09/943.535

DRIVING ARRANGEMENTS FOR ACTIVE MATRIX LCDS

SUBMISSION OF PROPOSED DRAWING CORRECTIONS

Figure 18

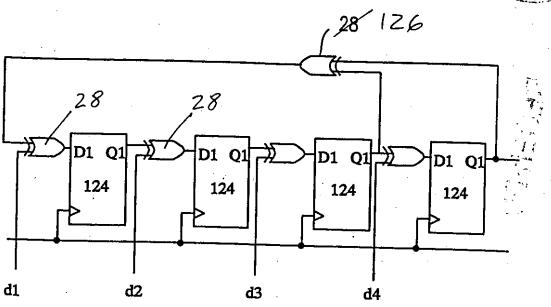
The presently submitted drawing sheet, Figure 18, contains proposed corrections of the reference numbers. The Figure 18 shown in the originally filed drawing sheet omitted and contained erroneous reference numbers, as a result of typographical errors. Applicants respectfully request entry of the corrected drawing sheet submitted herewith, and submit that such corrections do not constitute new matter.

The requested drawing changes are supported in the specification as filed. Figure 18 is similar to Figure 17, as indicated in the Brief Description of the Drawings at page 13 of the specification. Figure 18 includes the elements of Figure 17, and also includes the additional XOR logic gates 28, mentioned at page 13, lines 14-16 and described at page 26, lines 13-15. In the originally submitted Figure 18, these additional XOR logic gates 28 were not identified by reference numerals. In addition, in the originally submitted Figure 18, the XOR logic gate 126 shown in Figure 17 was erroneously identified by reference numeral 28.

Thus, the presently submitted proposed drawing corrections propose (a) to insert the reference numeral 28 to identify the additional XOR logic gates which were added to the embodiment shown in Figure 17 to provide the embodiment shown in Figure 18; and (b) to correct the reference numeral identification of the single XOR logic gate 126 from the erroneously applied reference numeral 28.
